Amphenol Taiwan Corporation

Product Change Notification

Part Numbers Concerned :	G64RXXXXXXHR	Originator:	Sondra Sang
Product Description:	EXTREMEPORT Z-LINK CONNECTOR, R/A RECEPTACLE	Issue Date:	2022/7/21
		PCN NO:	NE-22122
Distribution:	1. Modified packing Q'TY, added triangle pillars 2. For manufacturing optimization to modify 1C/ 2C/ 4C housing structure	Old Rev.	AX15
		New Rev.	AX16

1 Modified packing Q'TY and added triangle pillars

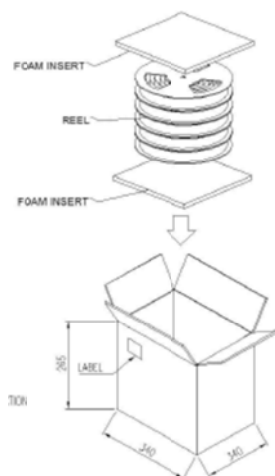
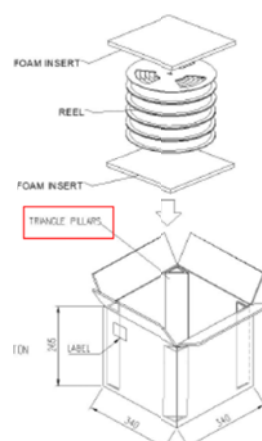
PART NUMBER	DIM. A	DIM. B	DIM. C	PCS/ REEL	REEL/ CARTON	CARTON (PCS)
G64RXXXX2HR	44	40.4	24	170	3	510
G64RXXXX3HR	56	52.4	24	170	2	340
G64RXXXX4HR	88	84.4	24	170	2	340
G64RXXXX5HR	88	84.4	24	170	2	340
G64RXXXX6HR	44	40.4	20	270	3	810
G64RXXXX7HR	56	52.4	20	200	2	400
G64RXXXX8HR	72	68.4	24	170	3	510

PART NUMBER	DIM. A	DIM. B	DIM. C	PCS/ REEL	REEL/ CARTON	CARTON (PCS)
G64RXXXX2HR	44	40.4	24	70	5	350
G64RXXXX3HR	56	52.4	24	70	4	280
G64RXXXX4HR	88	84.4	24	70	2	140
G64RXXXX5HR	88	84.4	24	70	2	140
G64RXXXX6HR	44	40.4	20	70	5	350
G64RXXXX7HR	56	52.4	20	200	4	800
G64RXXXX8HR	72	68.4	24	70	3	210
